CERTIFICATE OF APPROPRIATENESS

Property: 711 E. 5th½ Street, Lots 4,5,6,7, Block 4, Freeland Subdivision. The property 6,250 square foot (50' x 125') interior lot.

Proposal: New Construction – Two story primary residence with one story detached garage

Recommendation: Denial - does not satisfy criteria

SOUTH ELEVATION – FRONT FACING E 5TH½ STREET - PROPOSED

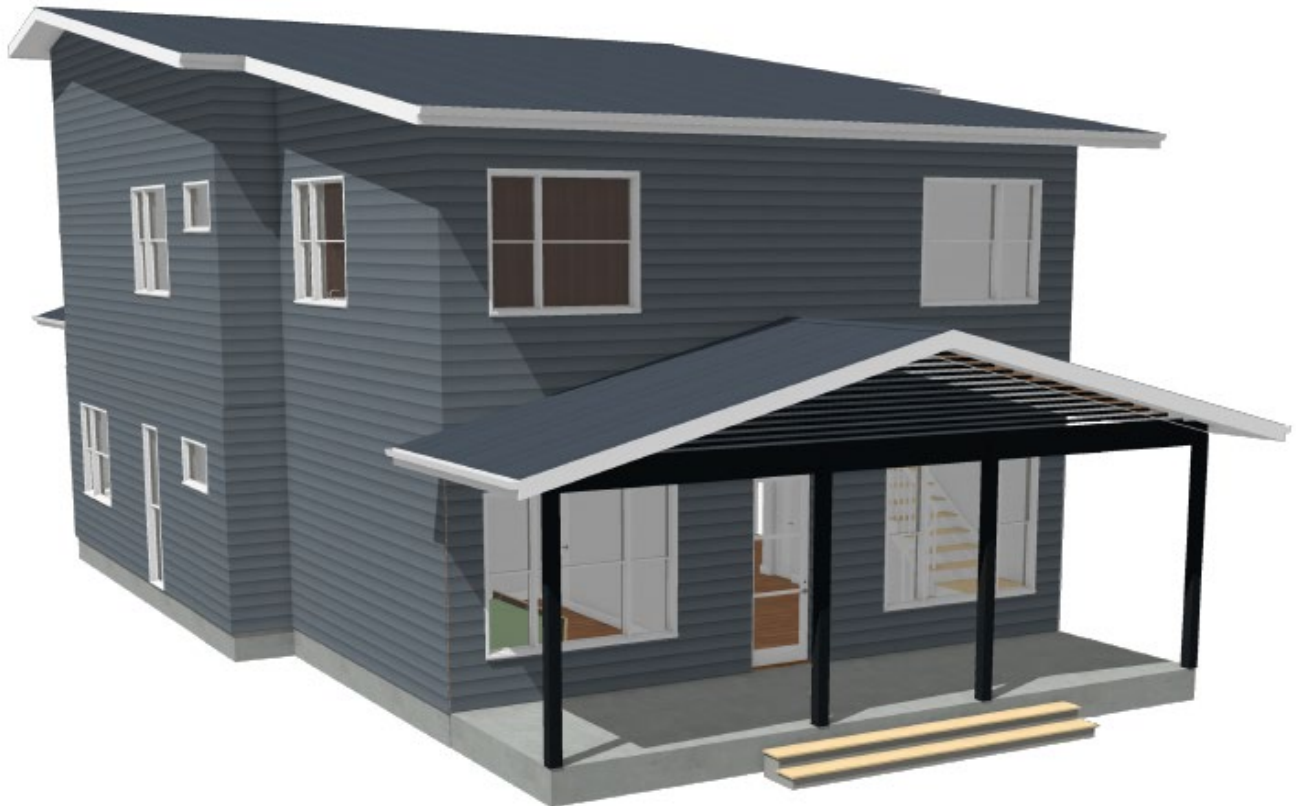
(2) The exterior features of the new construction must be compatible with the exterior features of existing contributing structures in the context area;
Exterior features of proposed design are not compatible with contributing structures in the context area (primary 1-story bungalows of under 2,000 sq ft). The asymmetrical roof pitch, profile, eaves, length, and overall massing are distinctly different to that of contributing context. Contributing context sharing the property line, for instance, is 6:12 and has a secondary pitch of 12:12, the recent addition for that property has a 6:12 pitch The proposed pitch on this project is 2:12. In addition, the window openings propose a similar problem of irregularity compared to the existing contributing context. The front door form is also atypical. All other contributing buildings in Freeland are one or one and a half story bungalows on the front elevation, while the proposed new construction is two story. (see criteria 4)

(4) The height of the new construction must not be taller than the typical height of existing contributing structures in the context area unless special circumstances, such as an atypical use, location, or lot size, warrant an atypical height, except that;
*Typical height in Freeland is that of a one or one-and- half story bungalow. The immediate contributing context at 709 has a **historic ridge height of 17'7."** In 2017, they received an HAHC approved COA for a two-story addition at the rear with a ridge height of 26'-10 1/2," **proposed ridge height for this project is 29'-5."***

(b) A new construction shall not be constructed with more than one story in a historic district that is comprised entirely of one-story contributing structures, except as provided for in design guidelines for an individual historic district.
Freeland is comprised of one or one and half story bungalows (with front ridge heights +/-17'). Some of the contributing buildings have second story rear additions, but none of them have a two-story front façade. Freeland does not have design guidelines.
